FINAL DRAINAGE REPORT
for
WINDERMERE FILING NO. 1

SF-21-026

**PCD-ENGINEERING REVIEW COMMENTS
IN BLUE BOXES WITH BLUE TEXT**

**EPC STORMWATER REVIEW COMMENTS ARE
SHOWN IN ORANGE BOXES WITH BLACK TEXT**

DETENTION BASIN OUTLET STRUCTURE DESIGN

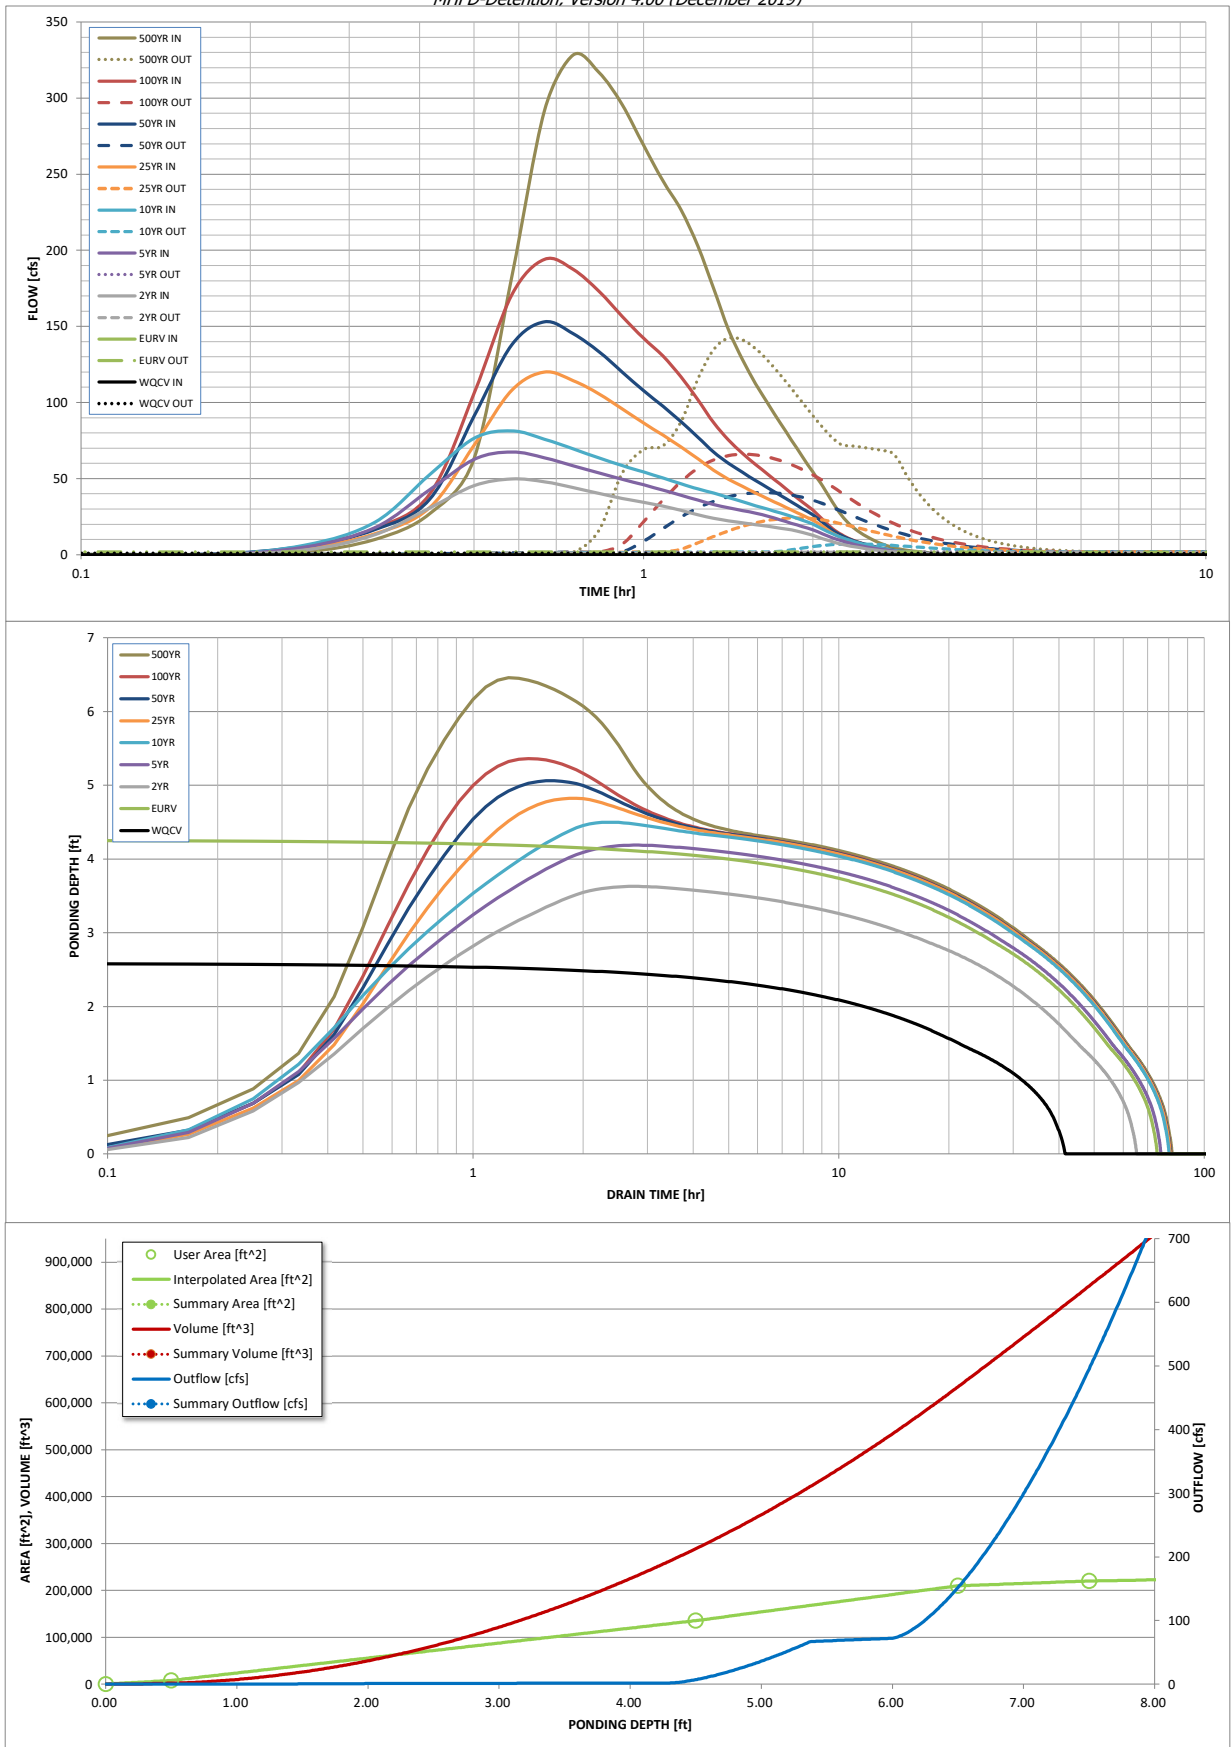
This should be ~1

DETENTION BASIN OUTLET STRUCTURE DESIGN

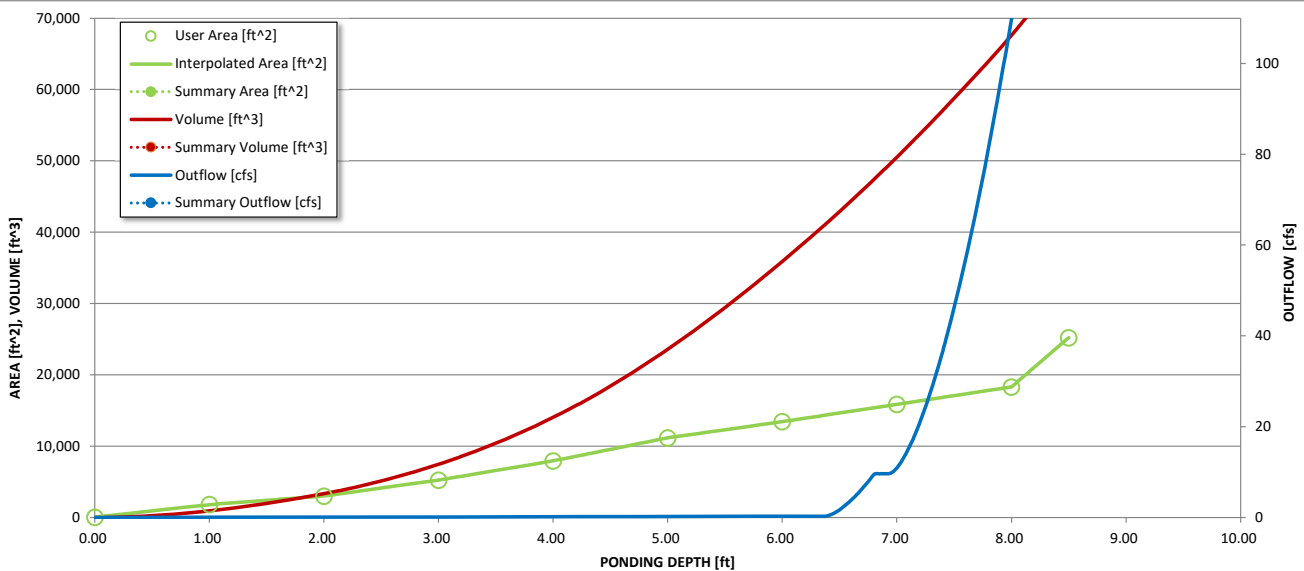
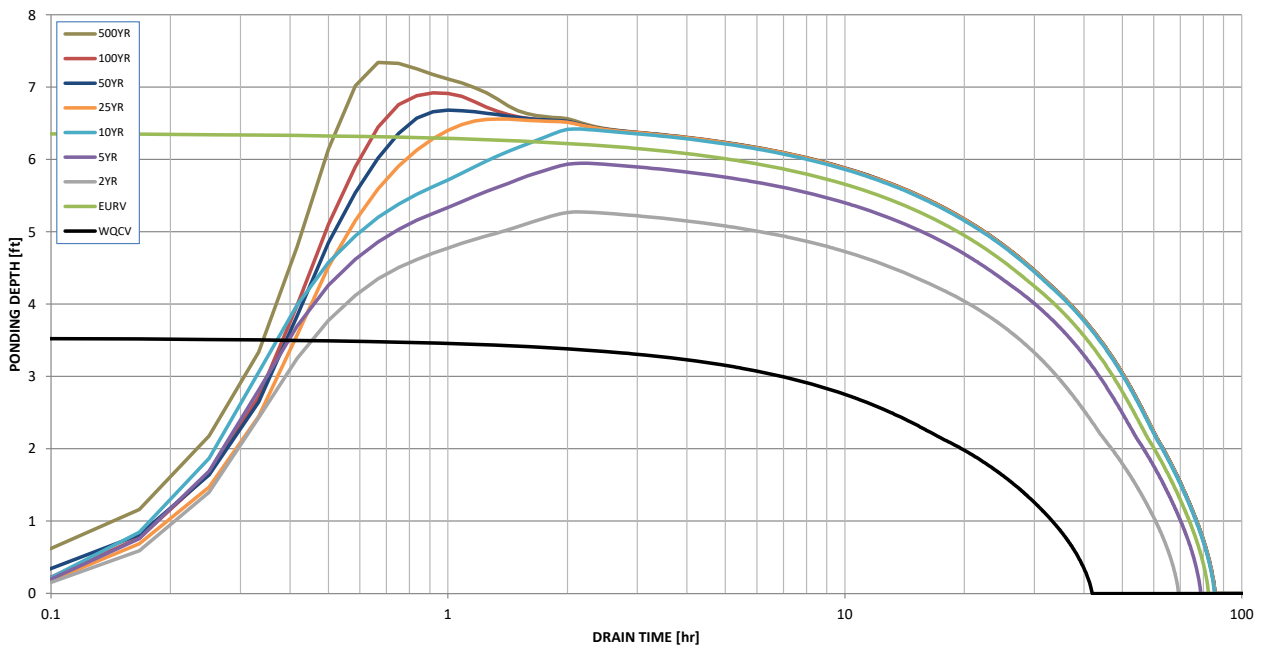
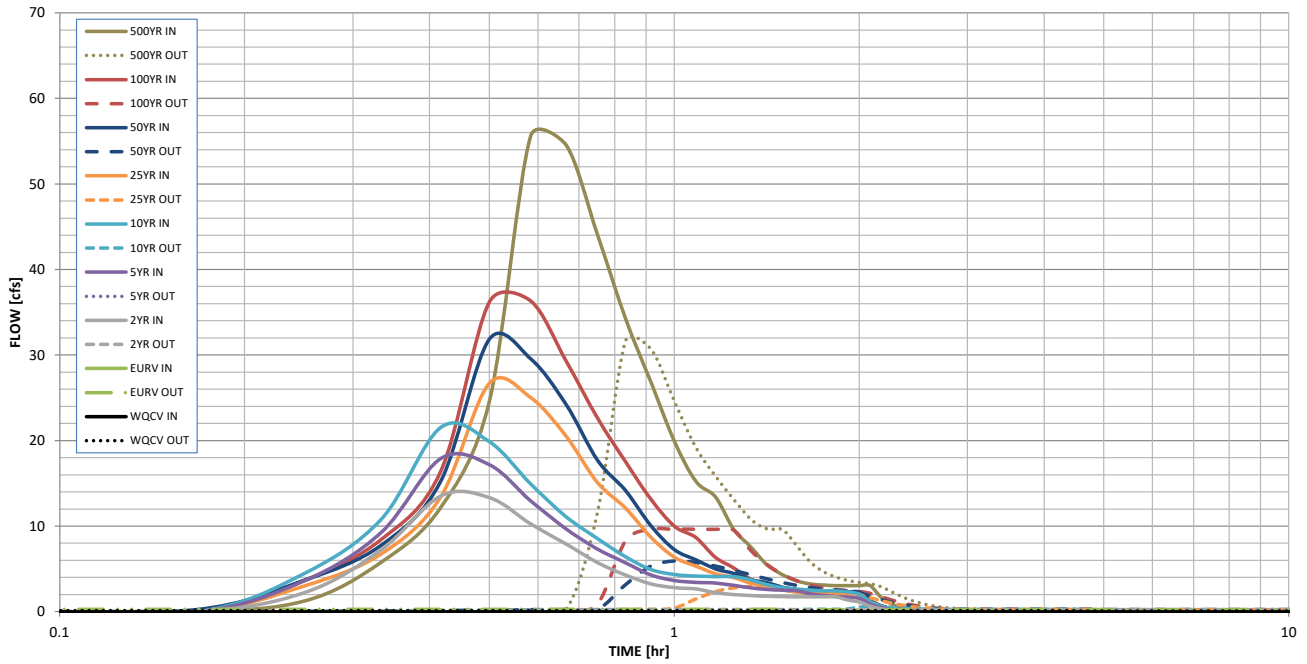
This should be ~1

PROJECT NO. 21187-01CSCV
DRAWING NO.
DR
SHEET: 2 OF 3

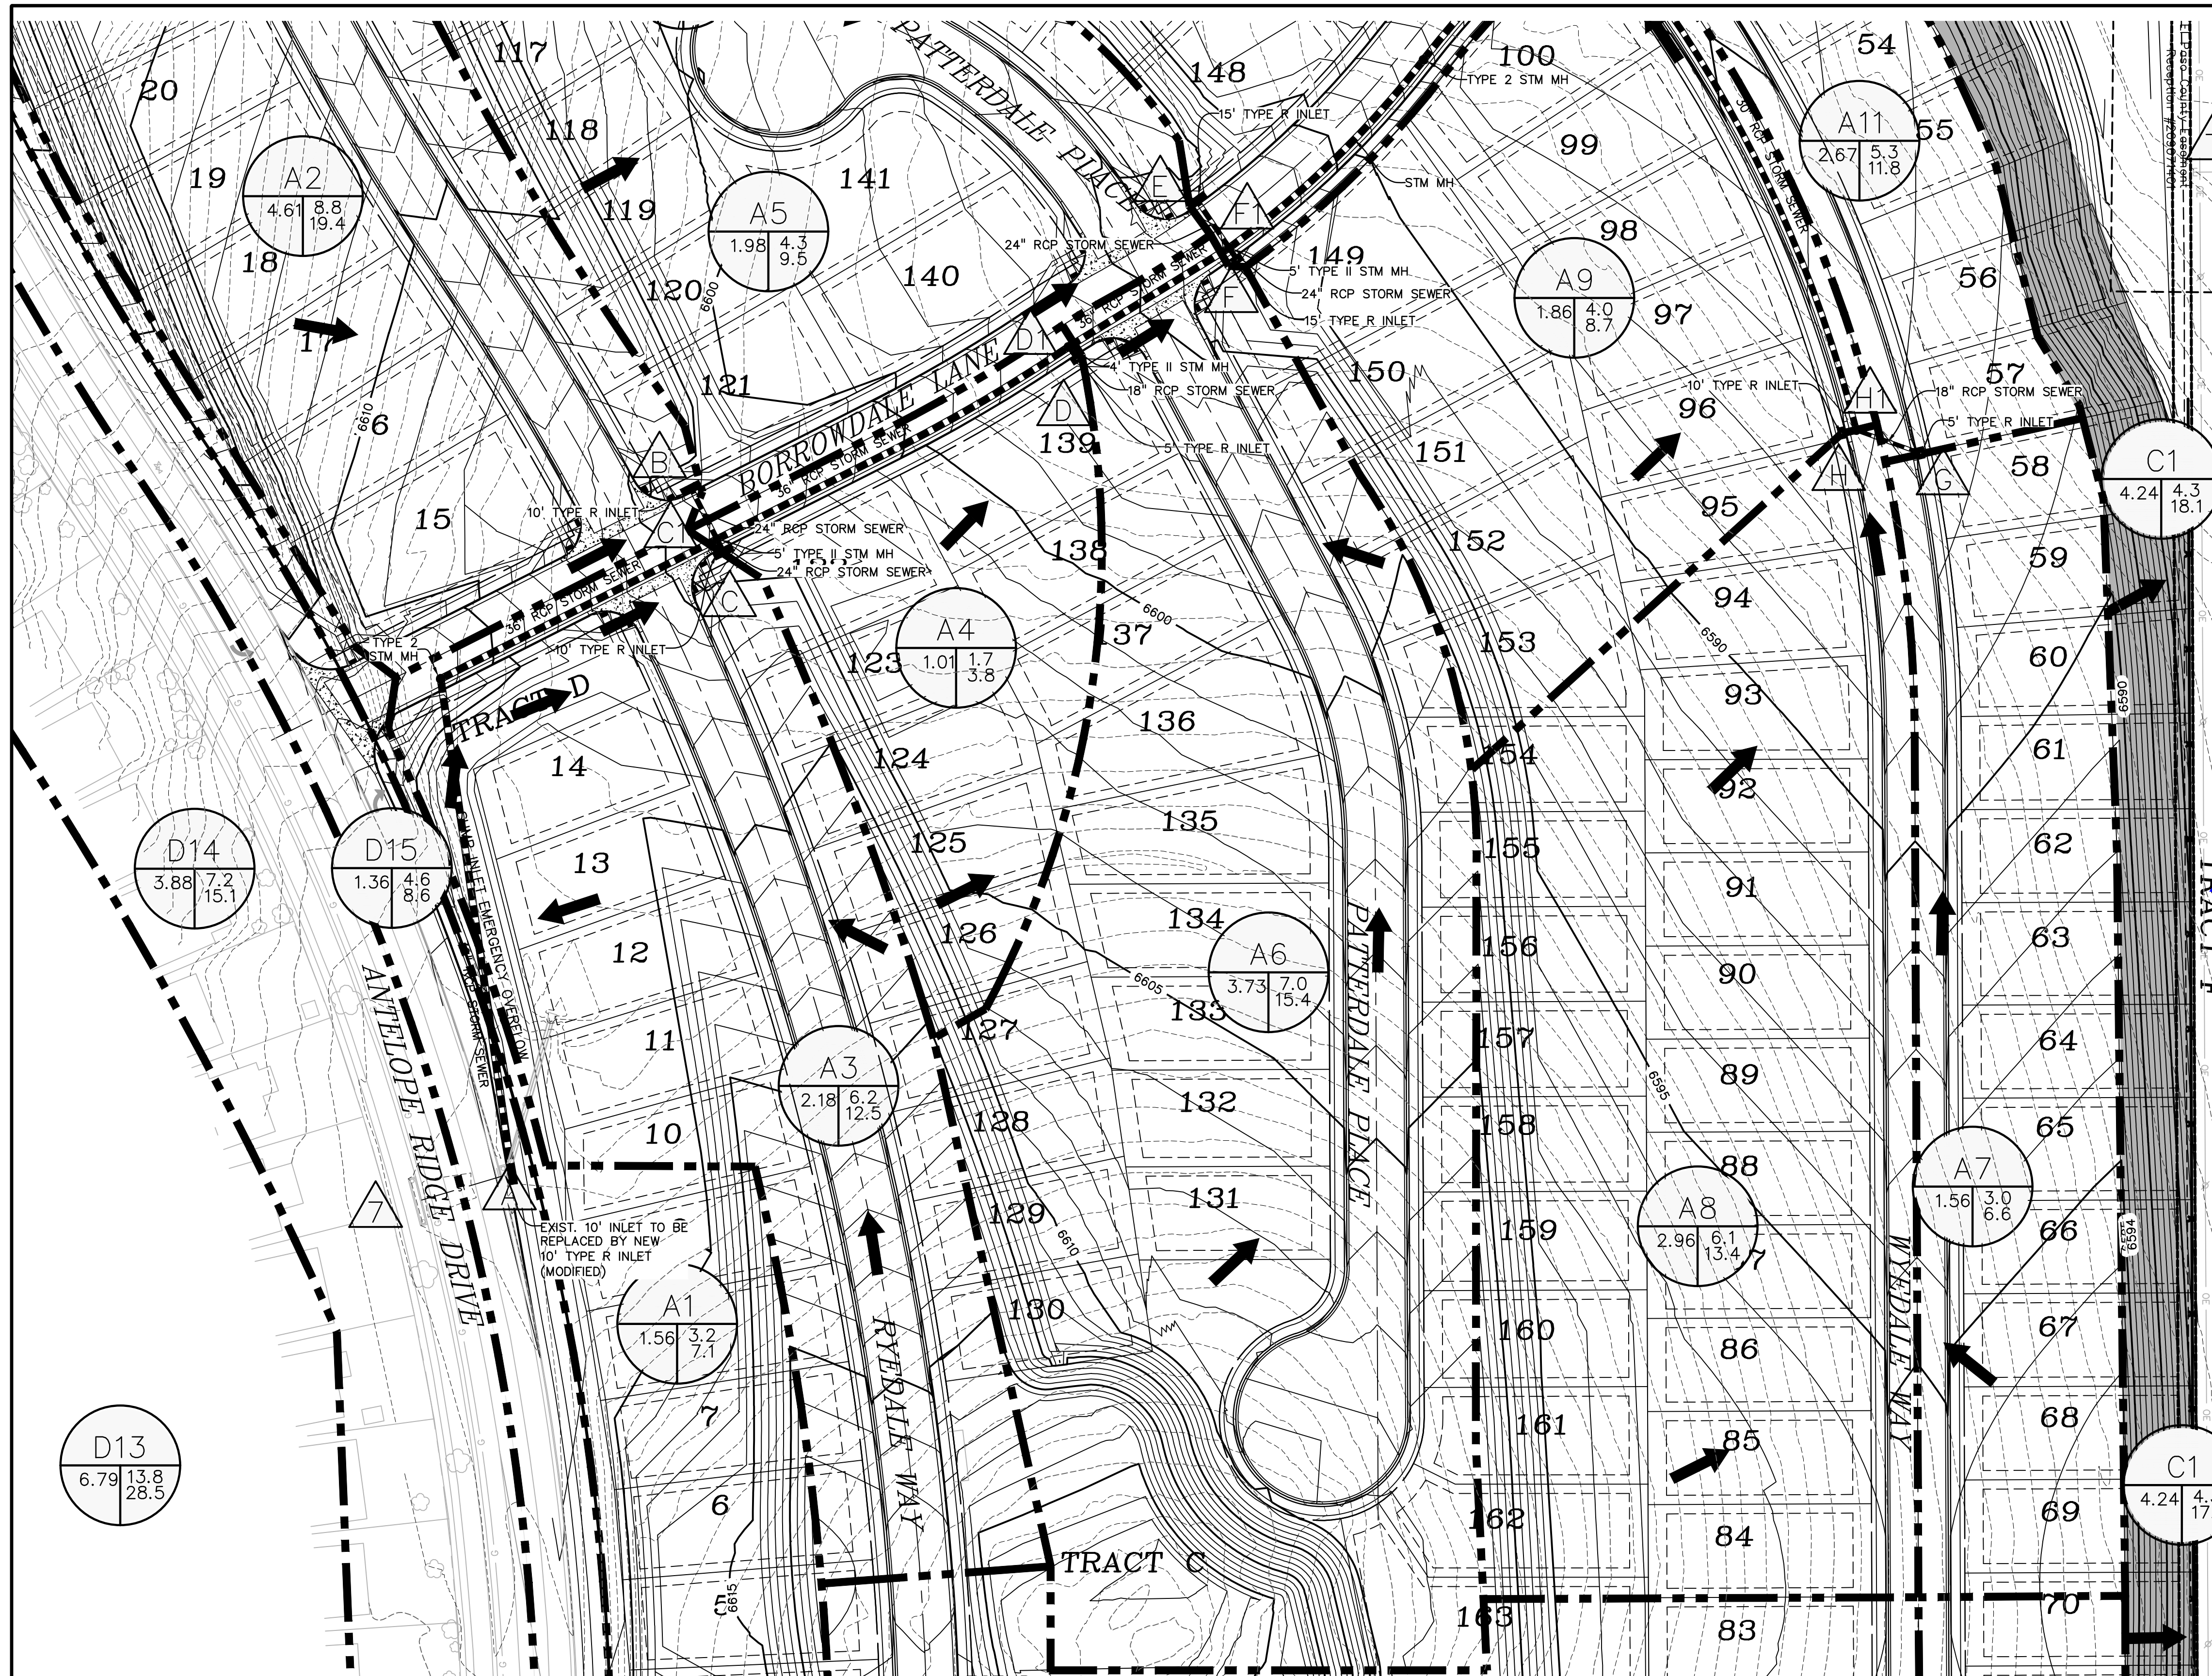
Does a more well-defined ditch need to be provided for the proposed >18 cfs runoff into this area? Provide analysis.

If Tract F is a runoff reduction Grass Buffer Strip, calculations and maintenance requirements need to be provided.
